Commission Agenda Report

Planning Commission Meeting
06-15-26
Item 3.B.2.

Subject: De Minimis Waiver No. 24-009 – An application for a replacement onsite wastewater treatment system for a parcel damaged by the Woolsey Fire

De Minimis Waiver for OWTS

OWTS SITE PLAN

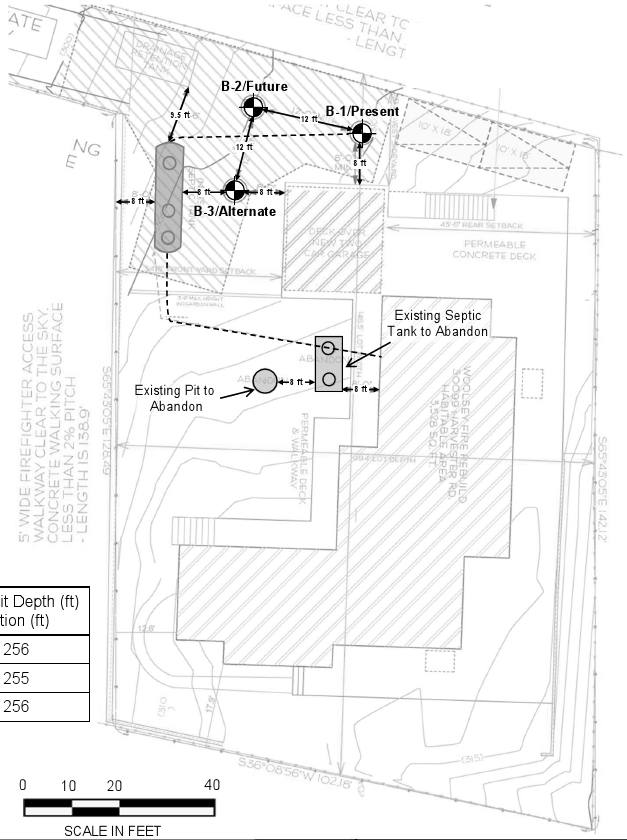
Revised Architectural and Grading Plans have been submitted for review under DMW 24-009 due to the relocation of a storm water detention tank. Please contact the City of Malibu Planners, Coli Turner and Aakash Shah, to further discuss the relocation of the tank.

3) **Existing OWTS to be Abandoned:** Final plans shall clearly show the locations of all existing OWTS components (serving pre-existing development) to be abandoned and provide procedures for the OWTS' proper abandonment in conformance with the Malibu Municipal Code.

4) **Worker Safety Note and Abandonment of Existing OWTS:** The following note shall be added to the plan drawings included with the OWTS final design: "*Prior to commencing work to abandon, remove, or replace existing Onsite Wastewater Treatment System (OWTS) components an "OWTS Abandonment Permit" shall be obtained from the City of Malibu. All work performed in the OWTS abandonment, removal, or replacement area shall be performed in strict accordance with all applicable federal, state, and local environmental and occupational safety and health regulatory requirements. The obtainment of any such required permits or approvals for this scope of work shall be the responsibility of the applicant and their agents.*"

OWTS and Stormwater Detention Tank on Final Architectural and Grading Plans: The final architectural site plan and grading plans must show the proposed stormwater detention tank and the onsite wastewater treatment system (OWTS), including the treatment tank, present/future dispersal area(s), and all lines of connection to the residence. The site plans must also show the existing OWTS labeled "to be abandoned".
